RE: *Engineering Review*
WRPD Application – 17 Jericho Road Solar Facility
Renewable Generation, LLC
ADE Project #2518.41

Atlantic Design Engineers, Inc. (ADE) has completed our engineering review of plans and application materials for the above-referenced project relative to a Special Permit request under the Water Resource Protection District (WRPD) bylaw. The plans and materials reviewed are as follows:

- 1.) Remediation Plan – Sheet L-1.0, revised dated 1/19/16
- 2.) Plan Showing Trees Cut Beyond Limit of Work – Sheet CR-1.0, dated 12/15/15
- 3.) Project Narrative, dated 12/17/15
- 4.) Proposed 25-foot Buffer Zone Restoration Plan, dated 1/20/16

DRAWING NO: CR-2.0
PLAN NO: L-4734

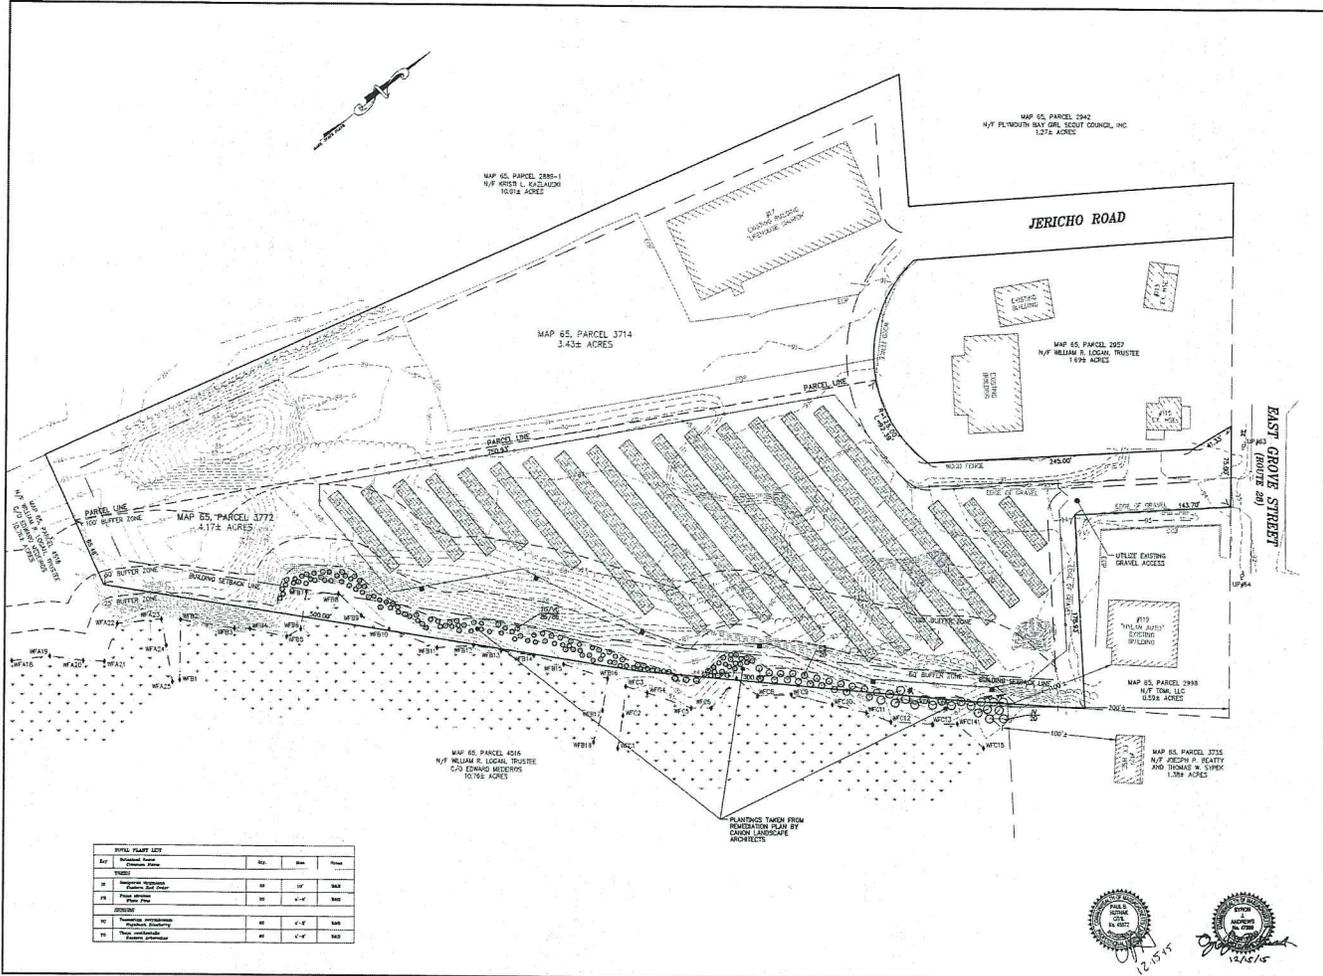
- 1.) The plan entitled “Plan Showing Trees Cut Beyond Approved Limit of Work” is stamped “draft” yet it is signed by both RLS and PE. Is this meant to be the final plan? The plan should show the limit of clearing/grading, not just stump symbols, to clarify the limit of disturbance. Also, label the distances from the clearing to the wetland edge and the total area of disturbance within the 25’ zone.
- 2.) Erosion control measures with appropriate notes and details are not shown or provided. Please provide.

REMEDIAL PLAN
 L-1.0

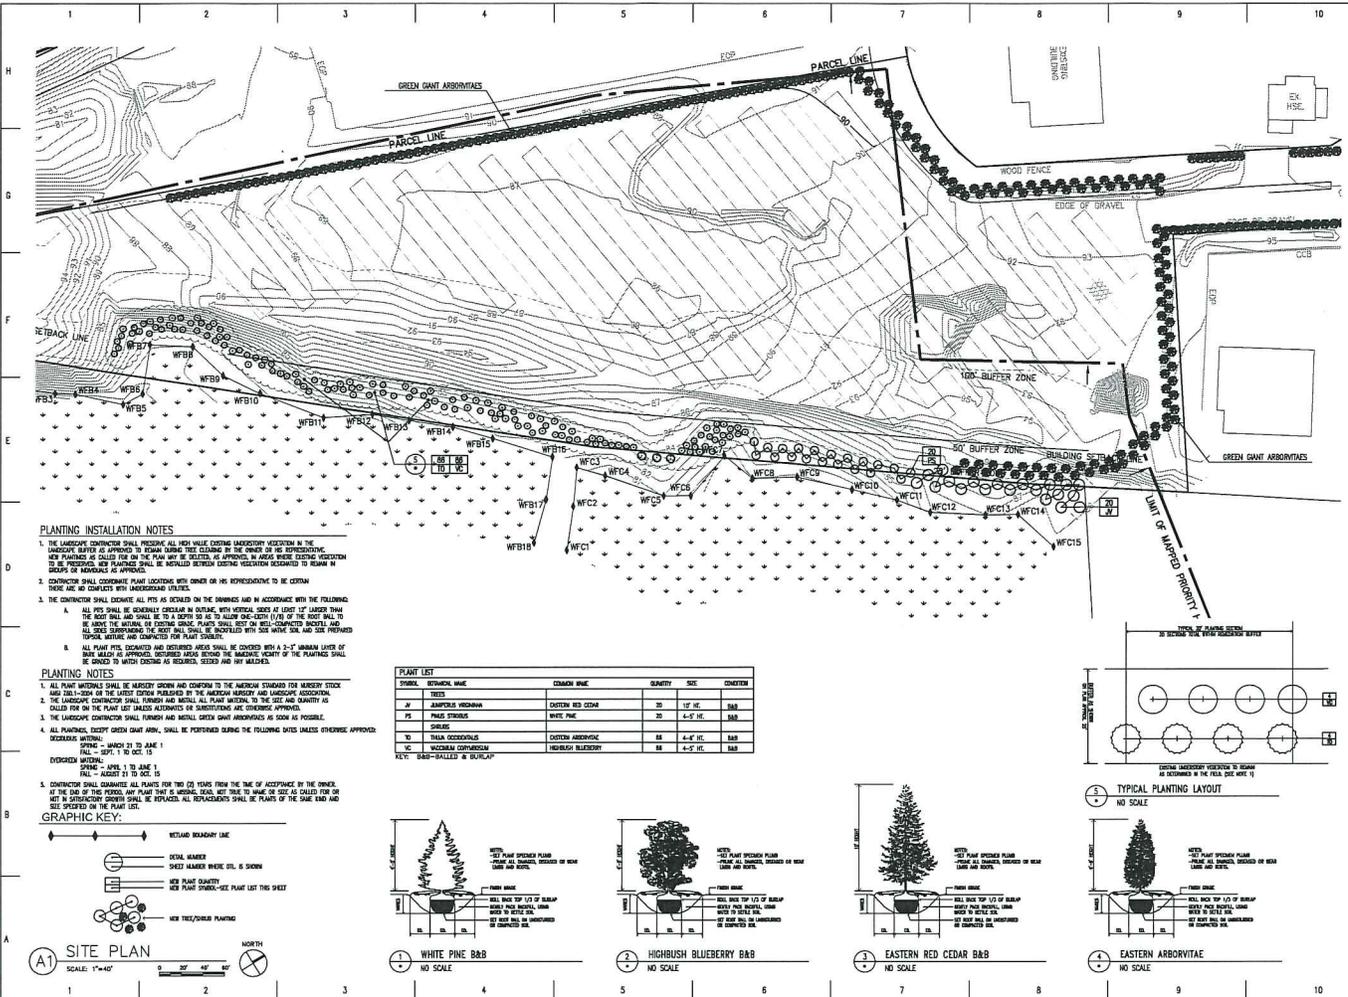
Recommendation: It is our opinion that the proposed planting plan adequately addresses the required remediation in the 25 foot wetland buffer. The proposed species, sizes and spatial arrangement will provide a naturalistic woodland edge upon installation and in the future. All the proposed plants should thrive where shown due to the matching of their cultural requirements (sun exposure, moisture, soils) with the existing conditions.

On visual inspection, the neighboring commercial metal building (over 200 feet away) was barely visible from the clearing looking east on a cloudy morning. This view should be eliminated when the proposed trees in this area are planted. The remediation trees there are mostly evergreen and there is also a proposed double row of evergreen Giant Arborvitae at 10 feet on-center spacing that is an additional perimeter screening outside the 25 foot buffer.

The planting notes state a "2 year plant guarantee." The smaller sized plant material will have a better survival rate than larger, more mature nursery stock. However, in addition to the maintenance program outlined in Exhibit 4, item 6, applicant should provide a watering program during dry spells through the establishment period of the plants and seeded areas.

3) The constructed site is gravel and somewhat graded level to a steep slope of varying heights down to the erosion control fence and hay bales. The planting notes state that "Disturbed areas beyond the immediate vicinity of the plantings shall be graded to match existing as required, seeded and hay mulched." Exhibit 4, item 5, additionally states "any exposed soils within 25 foot buffer zone restoration should be hand raked and seeded with N.E. Conservation/Wildlife seed mix.

Recommendation: Because remediation plants have not been installed yet, this phase has not been completed. However, the existing gravel slope should be covered with 4 inches of loam prior to the raking and seeding.
